3GPP TSG_CN#6
ETSI SMG3 Plenary Meeting #6,
Nice, France
13th – 15th December 1999

NP-99435

Agenda item: 5.3.3
Source: TSG_N WG3
Title: CRs to 3G Work Item Real Time Non-transparent fax

Subject: BC-IE setting for Real-time non-transparent FAX

B.1.10.2 Teleservice 61, Facsimile group 3 in GSM

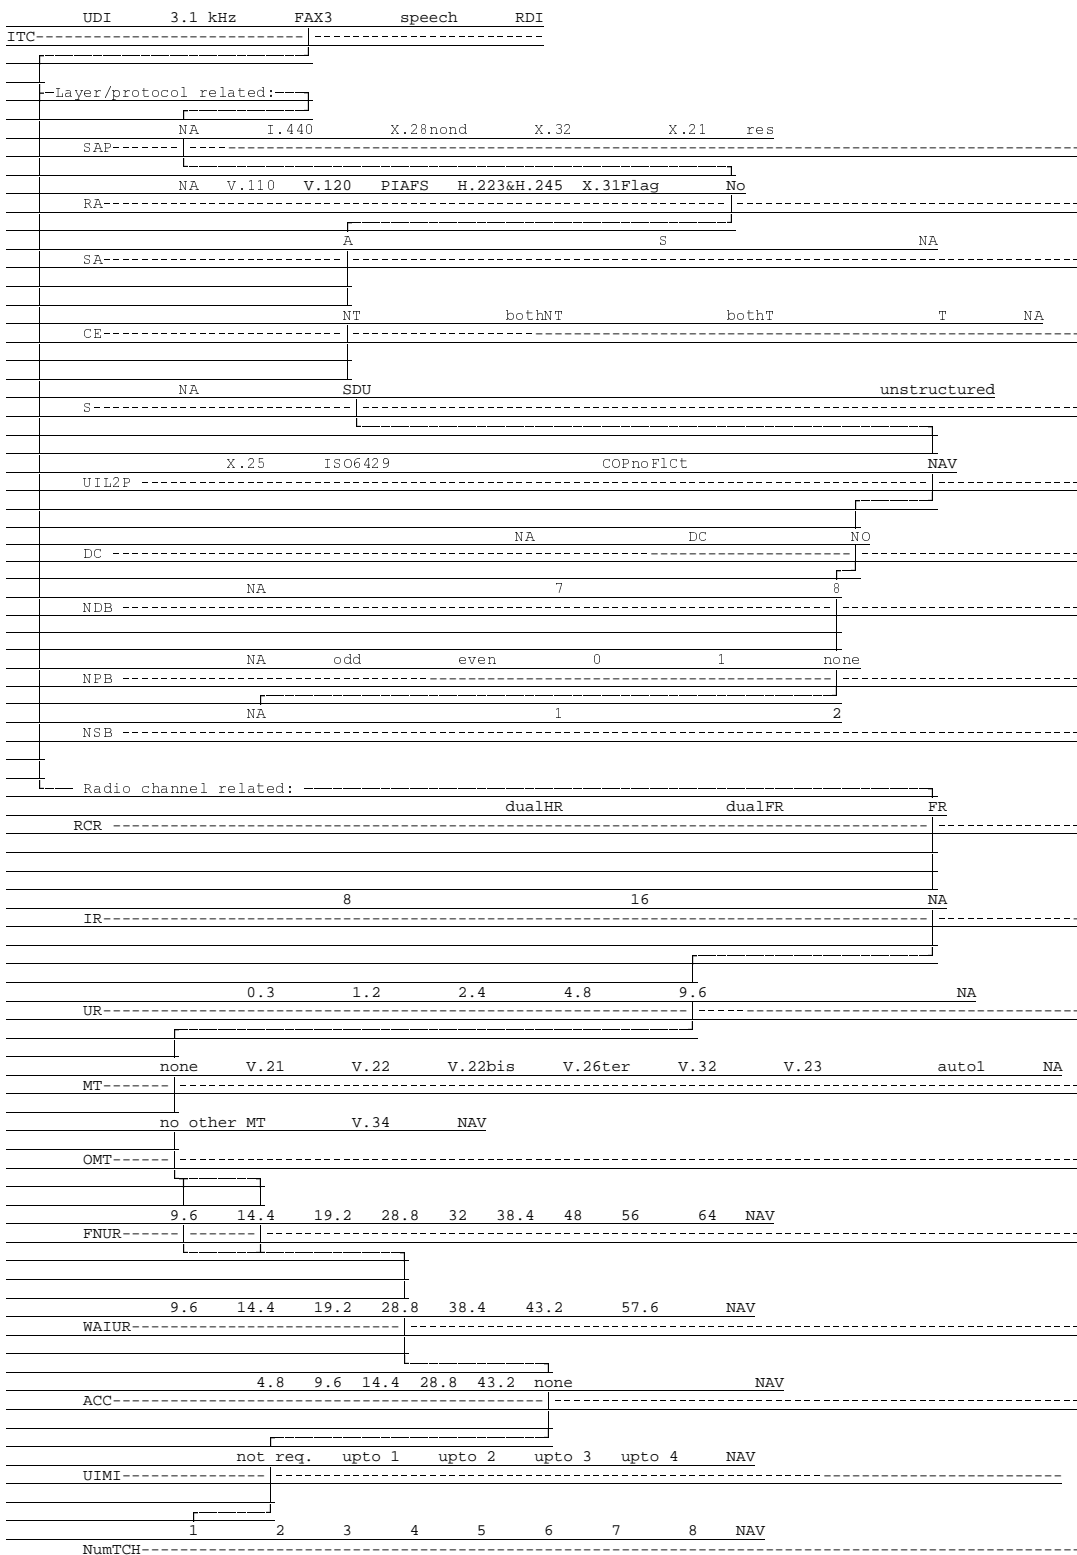
Reason for change: 1. Introduction of Asynchronous interface between FA Protocol and TAF
 2. Change related to user rate

Table 1: General mapping scheme for V-series interchange circuits

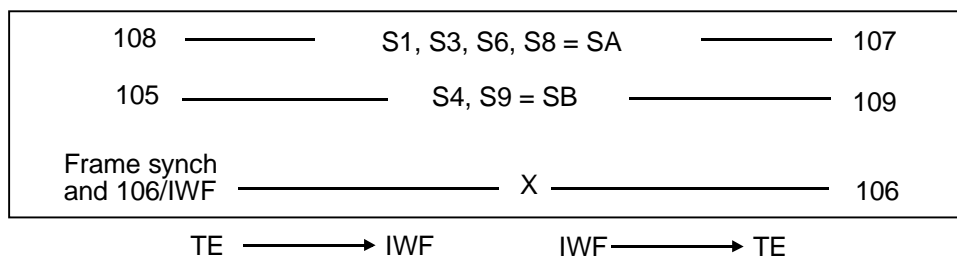
Reason for change: Introduction of Asynchronous interface between FA Protocol and TAF
